Response to SRFB Review Panel October 2012 Comments

Project Number: 12-1843

Project Name: Nason N1-KDIZ3 Floodplain Reconnection

Figure 1: 1966 Aerial Photograph of the N1 Floodplain Reconnection site. Source UW. Note the active floodplain channel path in the vicinity of the project area.

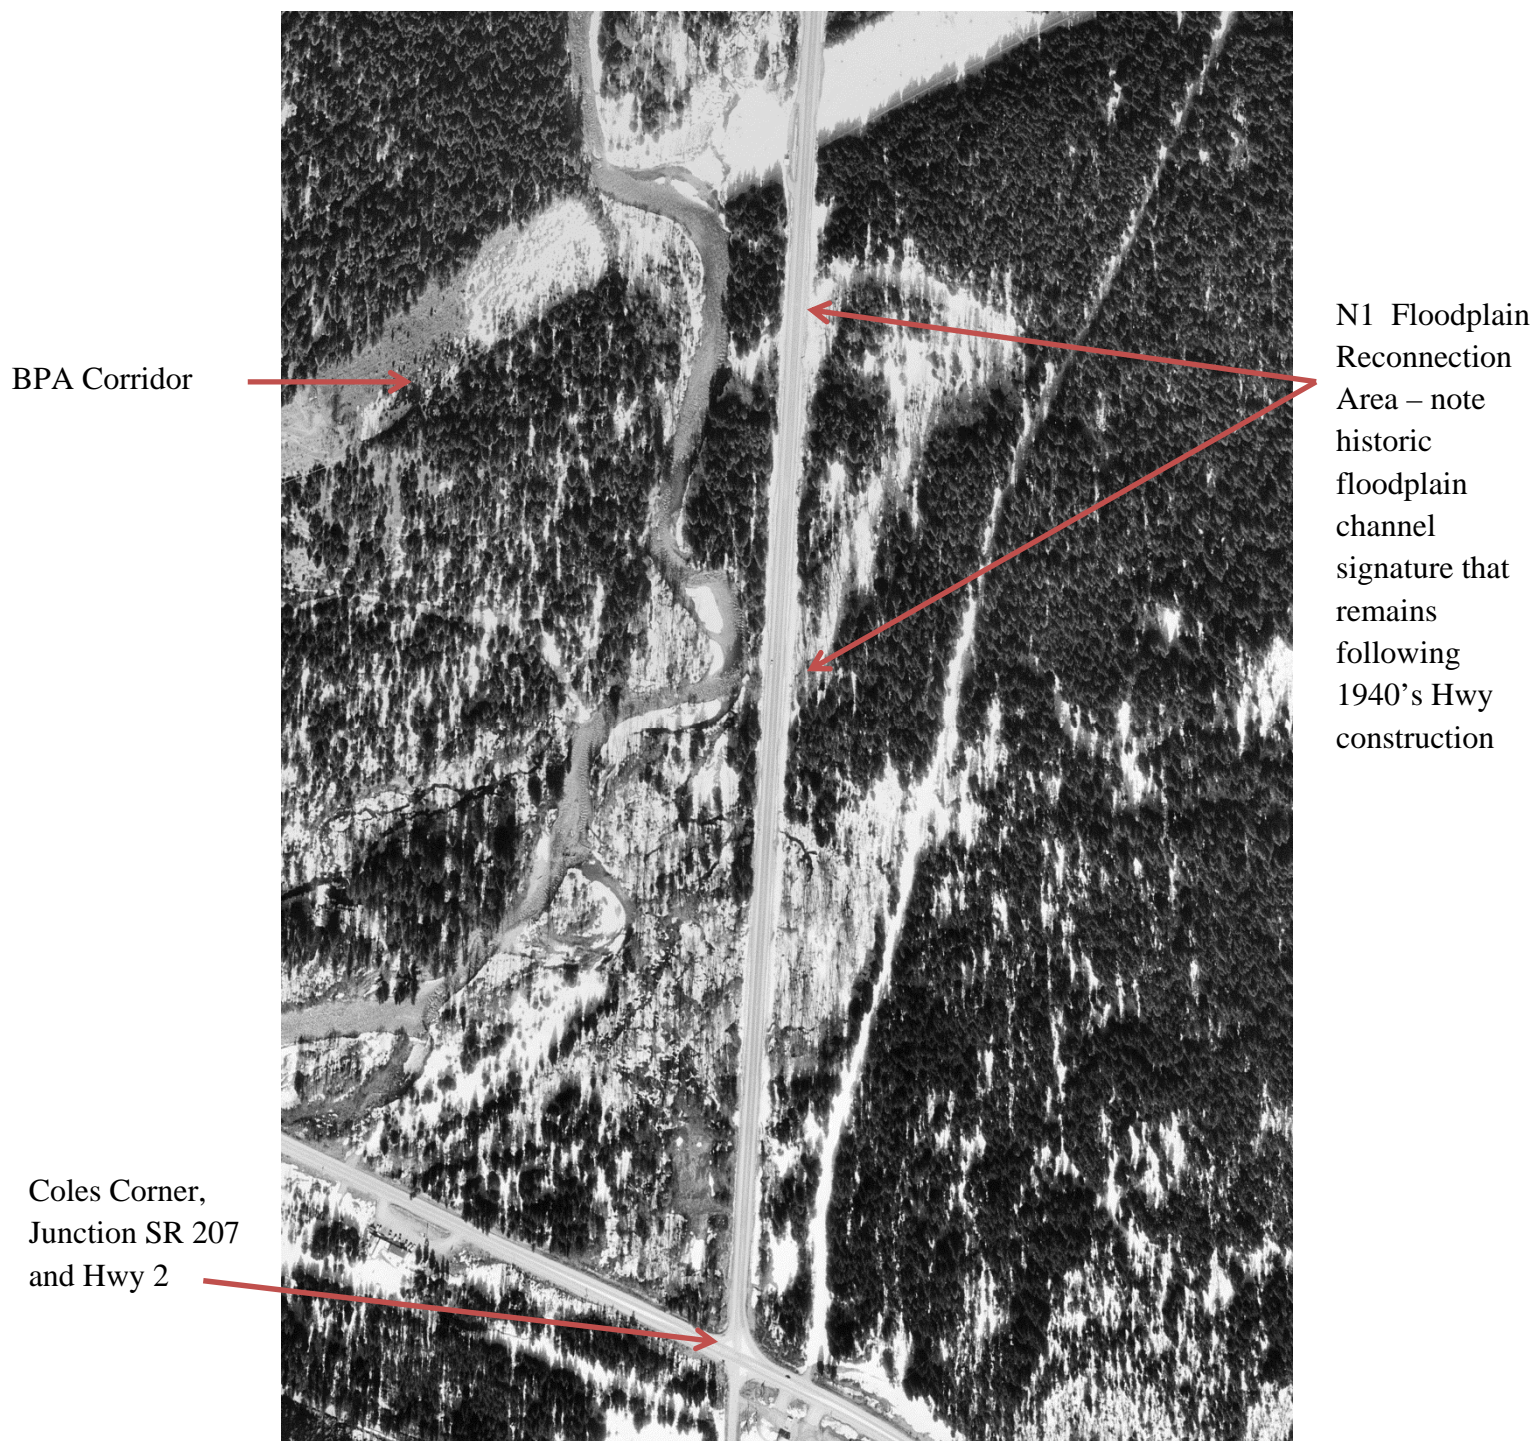
The proposed side channel reconnection to provide high flow refuge appears to provide only limited benefits for the costs. The proposed design would disturb a large amount of existing riparian vegetation which would limit the near-term function of the restored habitats.

This project proposes to restore the hydrologic connection between Nason Creek and a historic floodplain side channel. This side channel was likely activated on an annual basis similar to what is proposed with the improved culvert connection. A series of aerial photographs have been compiled to document historic conditions, successional vegetation patterns, and current conditions in the floodplain.

In the 1940's, Highway 207 re-location disconnected the N1 floodplain area from the mainstem of Nason Creek. The active floodplain area is still visible in the 1966 aerial photograph, Figure 1. The 1966 aerial photograph is the oldest aerial photograph for the project area as the 1936 and 1949 aerial photos found during the searches do not quite cover the project area. The 1981, 1992, and 2012 aerial photographs (Figure 2-4) document vegetation succession in the floodplain that has resulted from the floodplain disconnection resulting from Highway 207 construction. However, the 50+ foot wide break in canopy cover that remains at the downstream end of the floodplain is visible in Figures 2-5. This area remains wet through the spring due to elevated groundwater discharge from the surrounding hillsides. Photo 5 in the final project proposal documents current levels of spring inundation in the floodplain area.
